MAINE TURNPIKE AUTHORITY

ADDENDUM NO. 2

CONTRACT 2018.23

**MAINTENANCE GARAGE EXTENSIONS AND HVAC SYSTEM IMPROVEMENTS
IN AUBURN, CROSBY, GRAY, KENNEBUNK, AND LITCHFIELD**

SHEET NUMBER: E2

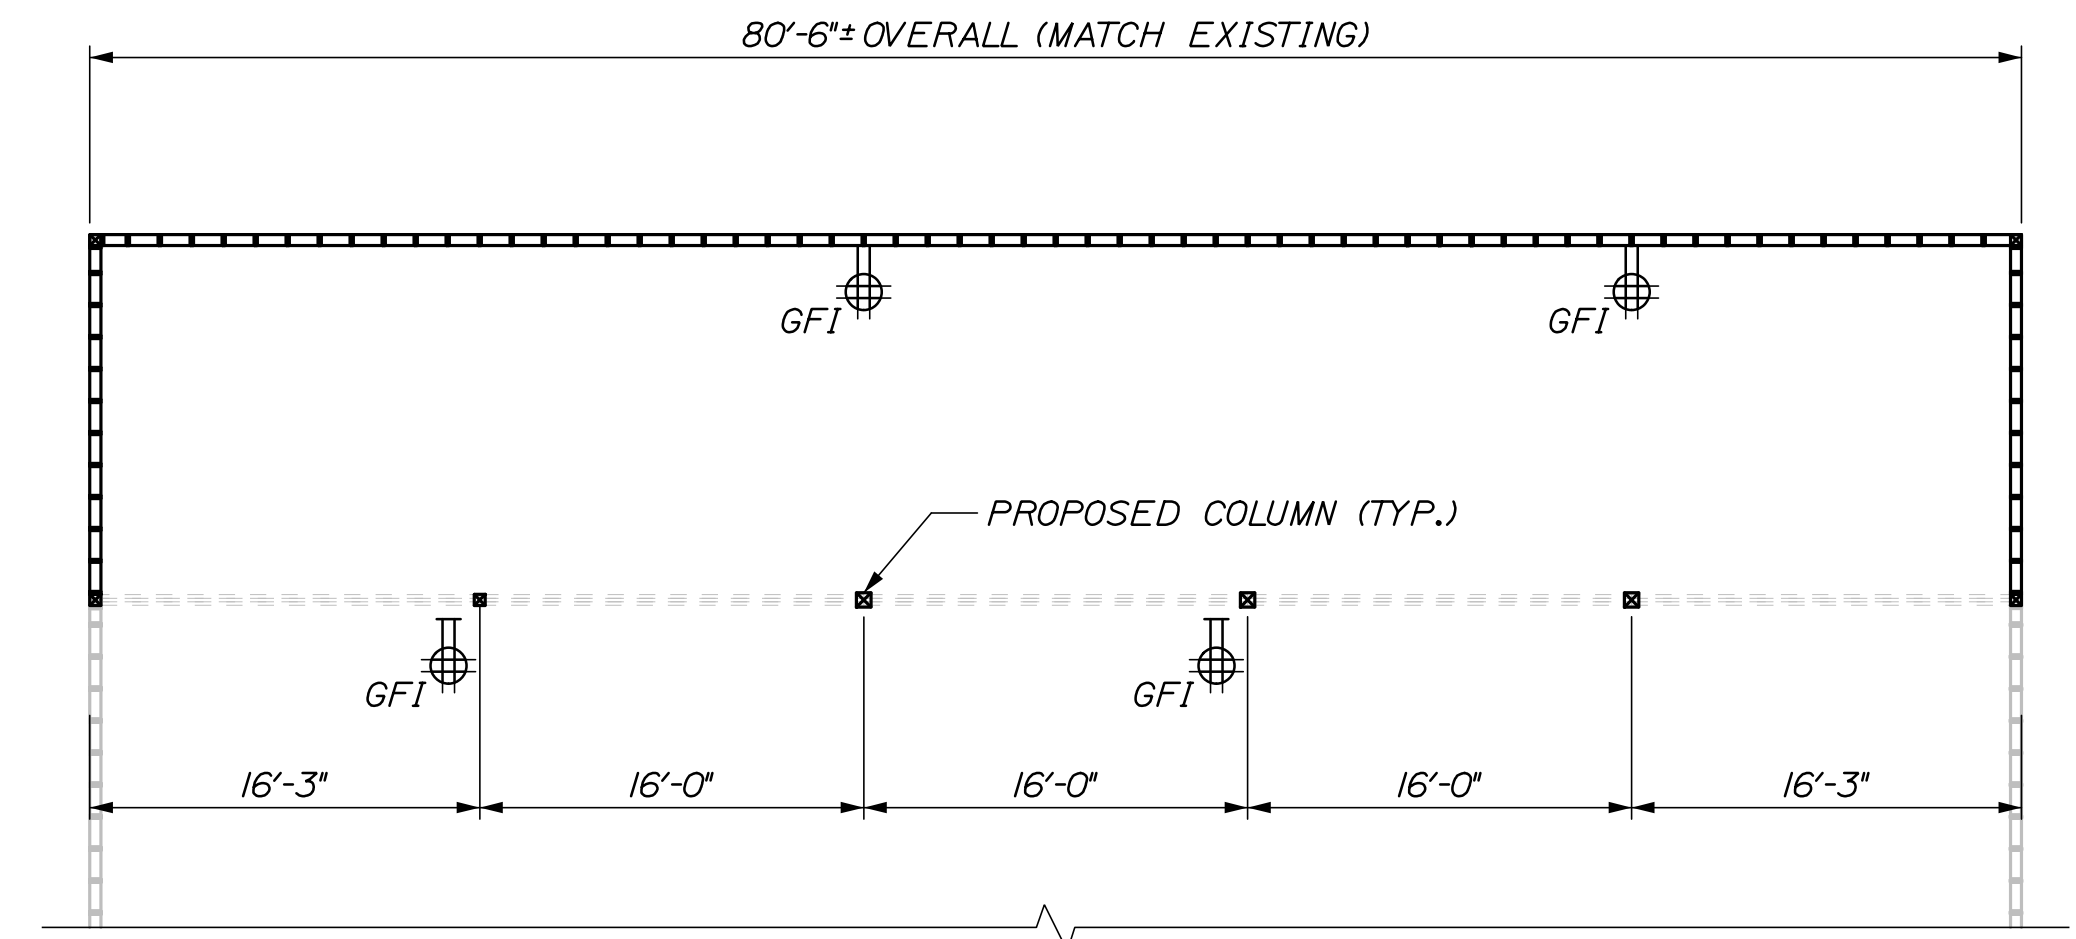
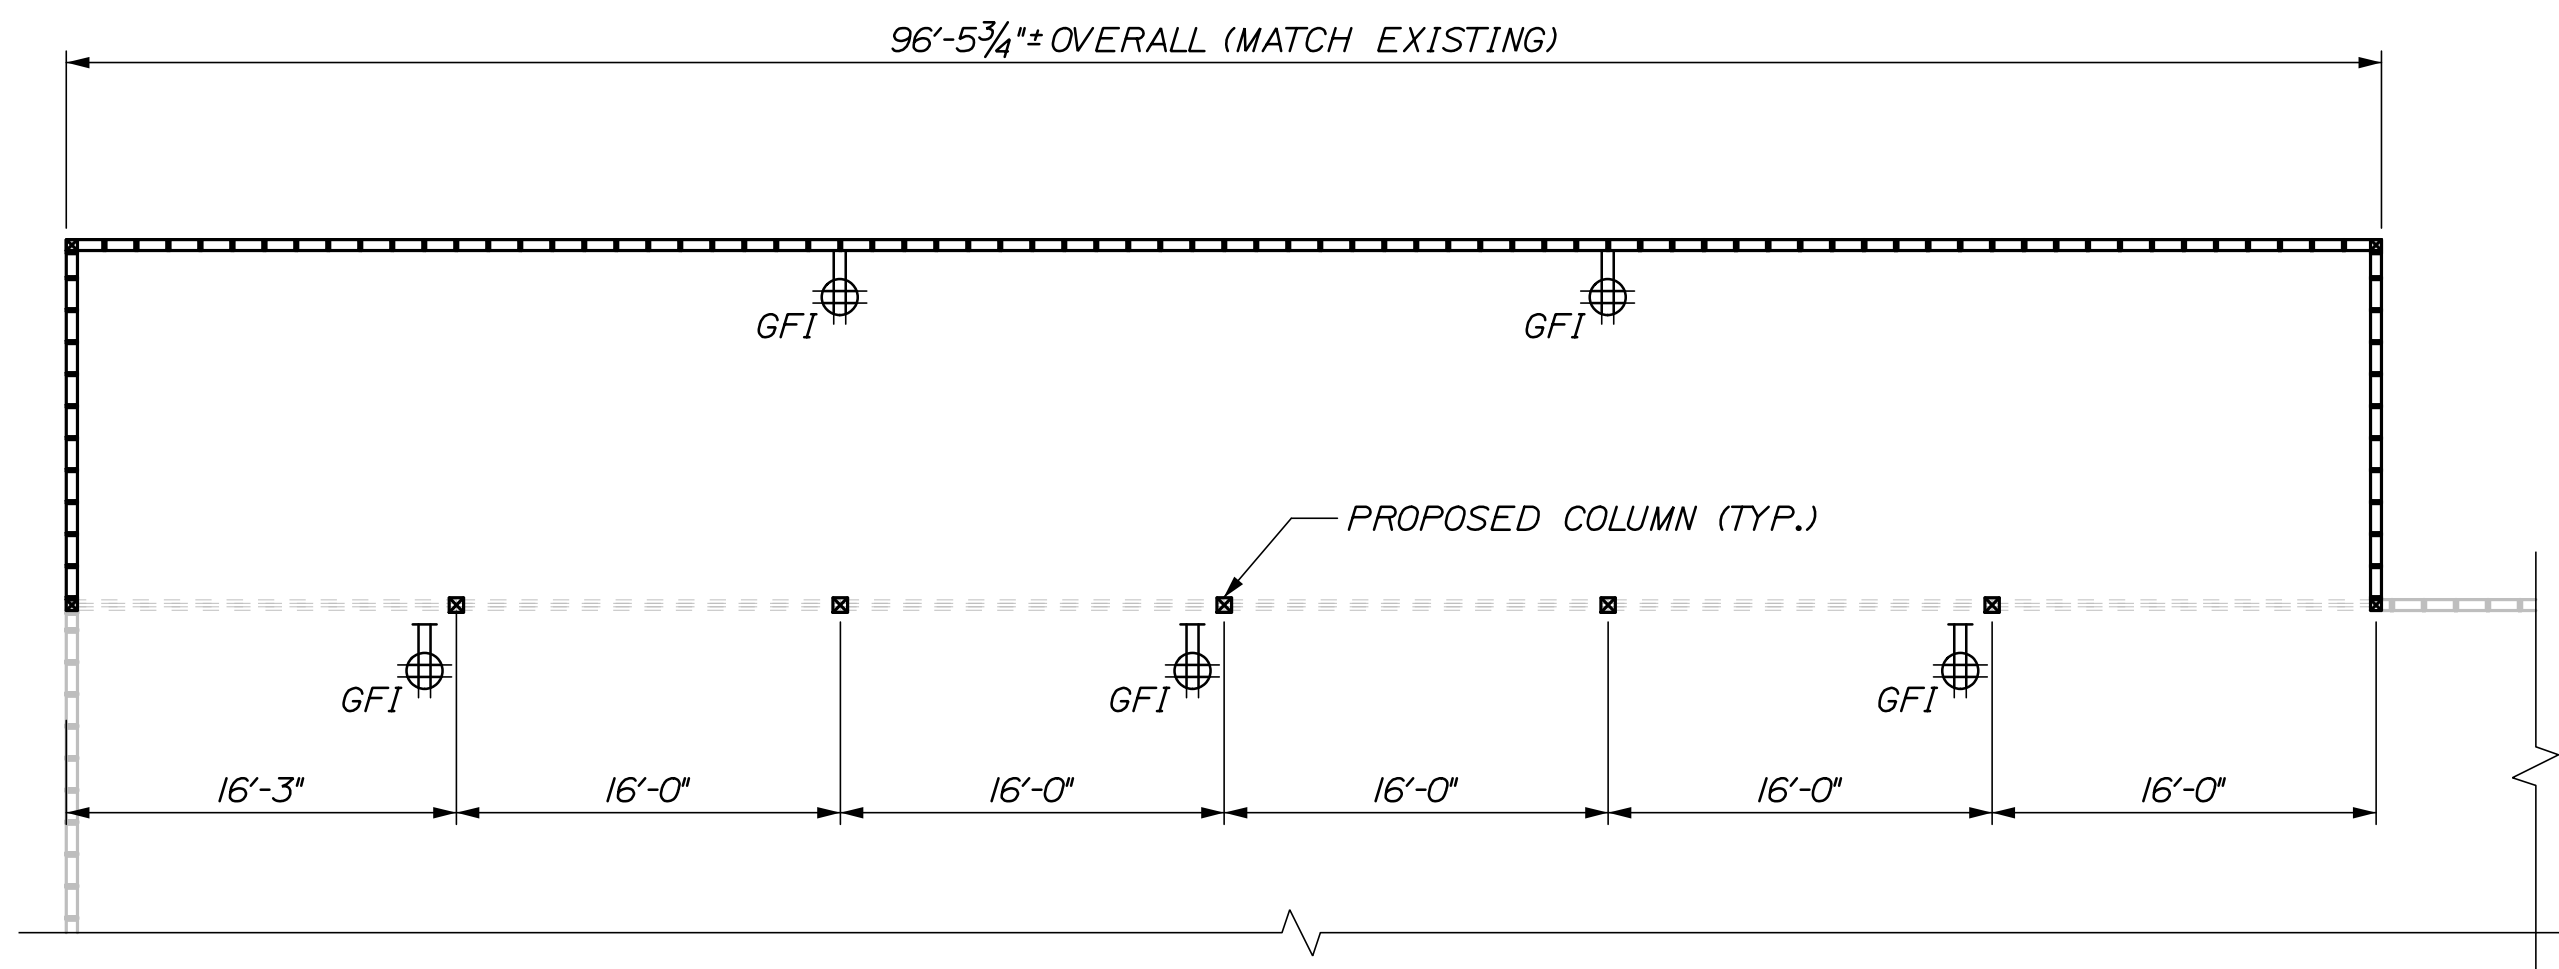
Question 7: 3 total exterior outlets? 1 quad and 2 duplex per building as noted on the power plans?

Answer: One exterior quad receptacle at each building as located by the Resident. 3 additional exterior duplex receptacles at all other buildings as located by the Resident, except Crosby #1 (5 bay), which will have 2 additional exterior duplex receptacles. One receptacle at each end wall of the buildings and 2 on the back wall of the buildings, except at Crosby #1 (5 bay), which will have 1 additional on the back wall. The Electrical Sheets E1 and E2 will be reissued with notes updated. The Quantity Sheet S2 will also be updated – see this addendum for updated plan sheets.

- ELECTRICAL NOTES:**
- ALL PROPOSED CONDUIT IN EXTENDED SECTION OF GARAGE SHALL BE SURFACE MOUNTED AND MATCH EXISTING FEEDER CONDUIT.
 - ALL RECEPTACLE BOXES SHALL BE SURFACE MOUNTED.
 - ONE EXTERIOR MOUNTED QUAD RECEPTACLE SHALL BE MOUNTED ON THE OUTSIDE OF EACH OF THE MAINTENANCE GARAGES. THE RECEPTACLES WILL BE LOCATED BY A MTA MAINTENANCE REPRESENTATIVE.
 - ALL NEEDED ELECTRICAL WORK SHALL BE INCIDENTAL TO THE LUMP SUM BUILDING ITEM.
 - THREE (3) ADDITIONAL RECEPTACLES SHALL BE INSTALLED ON THE EXTERIOR OF EACH BUILDING EXCEPT CROSBY #1. TWO (2) ADDITIONAL RECEPTACLES SHALL BE INSTALLED ON THE EXTERIOR OF CROSBY BUILDING #1. RECEPTACLES WILL BE FIELD LOCATED BY THE RESIDENT.
